Our Ref: 27485Let2

RE: INFORMATION REQUEST FOR FURTHER DETAILS NORTHSORE HAMILTON URBAN DEVELOPMENT AREA (UDA) DEVELOPMENT APPLICATION FOR MATERIAL CHANGE OF USE FOR MULTIPLE RESIDENTIAL (168 UNITS) AND SHOP AT 37B HARBOUR ROAD, HAMILTON.

This letter forms TTM's response to the traffic engineering issues noted in the Information Request issued by the ULDA dated 17 February 2012. The issues are addressed as followed:

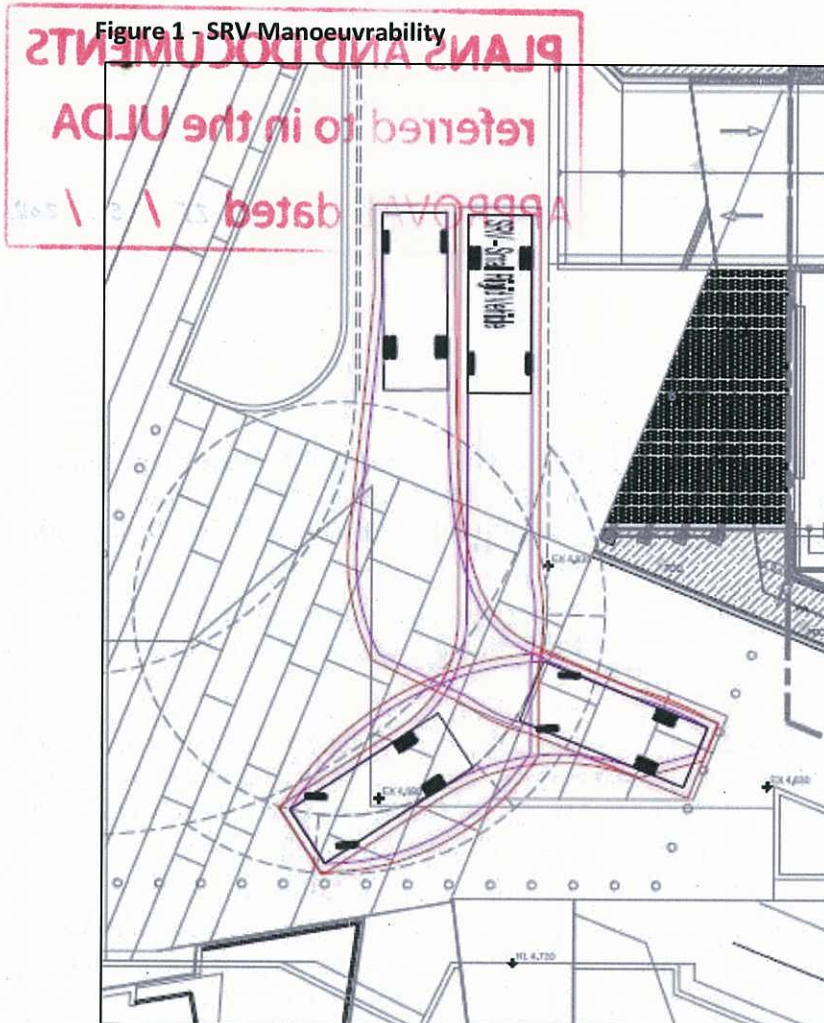
1. *A copy of the Service Management Plan and Waste Management Plan referenced by TTM in the submitted application was requested; however the response only referenced the Waste Management Plan. A copy of the Service Management Plan is required to be submitted and should address the issues raised in the Information Request.*

5. *In regards to Issue 3 of the Information Request, the response provided by TTM only refers to the potential vehicle/ pedestrian conflict which will be addressed through bollards. The issue of concern however was the impacts the whole of Portside service/loading bay outside Building 4 will have on the Building 2 drop off zone and pedestrian entry along with the pedestrian spine. We would expect the response to be driven by TTM rather than TTM commenting on Lat 27 plans. Please provide amended analysis which addresses the impact of the potential conflict.*

It is intended that the servicing requirements for Building 2 in terms of furniture deliveries, etc. will be facilitated via the service vehicle bay positioned between Buildings 2 and 4 as shown in Figure 1 below.

As shown in Figure 1, SRV's enter the bay in a reverse gear and exit in a forward gear.

Given the restriction of vehicle size, the infrequency of deliveries and the ability to schedule the deliveries outside of peak periods, it is concluded that the proposed service vehicle area between Buildings 2 and 4 will operate in a safe and efficient manner without impacting on the vehicular and pedestrian safety and amenity within the surrounding public realm.

The service area, as shown in Figure 1 above, has been designed to allow a Small Rigid Vehicle (2t) to park clear of the internal roadway whilst also allowing the passenger set down facility to continue to operate.

PORTSIDE WEST CARPARK MASTERPLAN BASEMENT

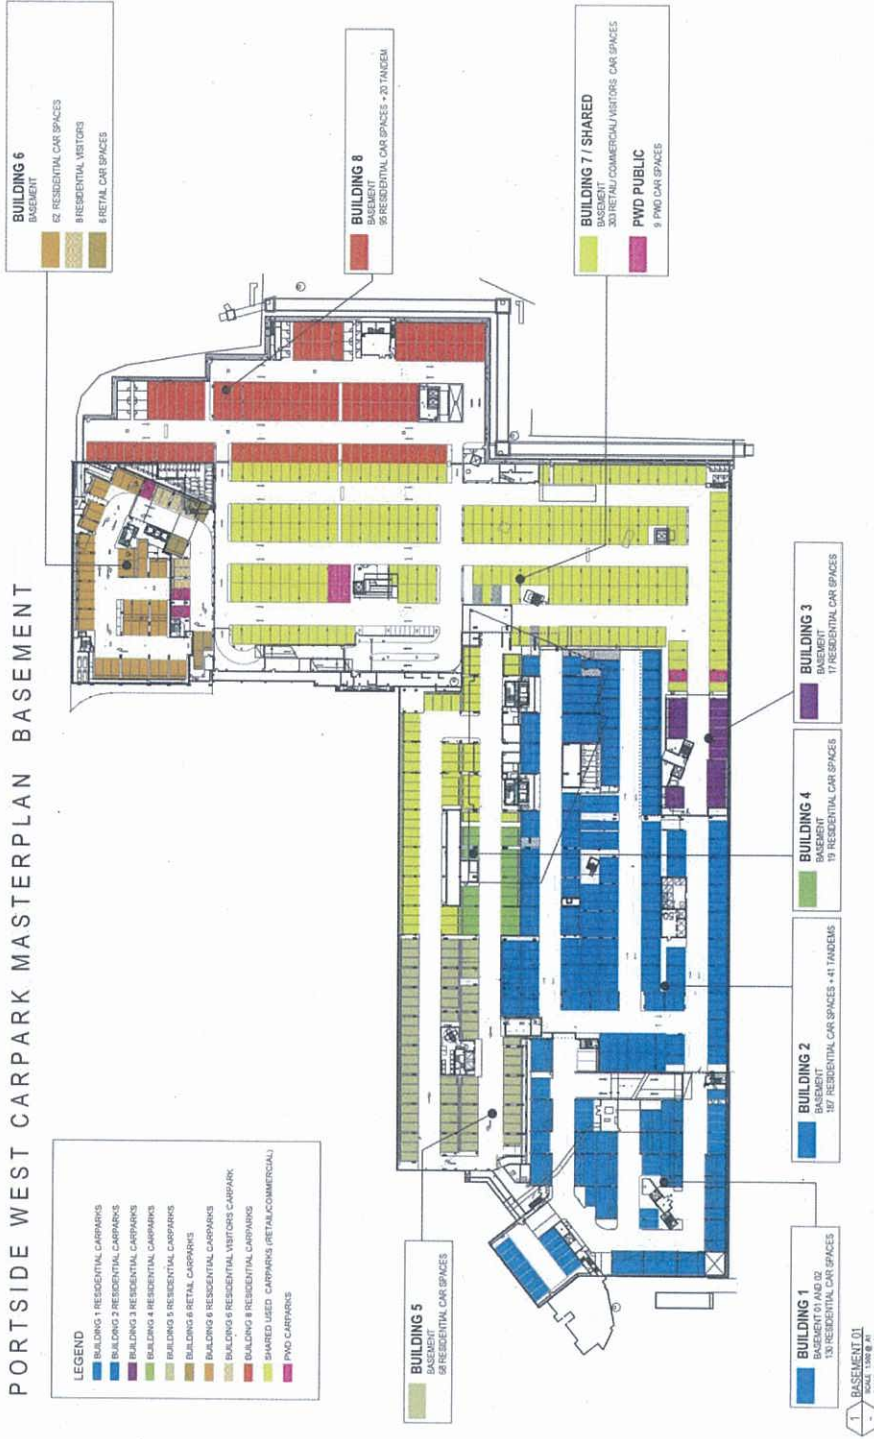
- c) *"It is considered that there is scope for dual use of the shared retail car park by visitors to the apartments." The ULDA have asked for a plan identifying the breakup of car parking across the whole Portside development to gain an understanding of how all the basement parking is assigned to each Stage and use. Provide information identifying the location and number of all car parks across the developments, including retail car parking.*

As per the ULDA's request Cottee Park have prepared plans, included in Appendix A, identifying the allocation of car parking across the wider precinct. These plans identify that 1477 car parking spaces will be ultimately provided within the precinct to facilitate the car parking demands associated with the land-uses provided for Buildings 1-8 (it is noted that other sites within the precinct will have separate parking facilities not linked to the common basement associated with Building 1 – 8). Of these, 1007 spaces will be allocated as "private" residential parking and 470 shared "public" spaces to be utilised for retail, commercial and residential visitor parking.

Notwithstanding this, it is considered that the number of PWD spaces within the shared parking areas is sufficient to cater for the various existing and proposed land-uses within the precinct. Inspection of the plans prepared by Cottey Parker included in Appendix A confirms that 16 spaces of the 470 spaces provided within the shared parking areas are allocated as PWD, which represents 3.4% of the total car parking supply within these areas.
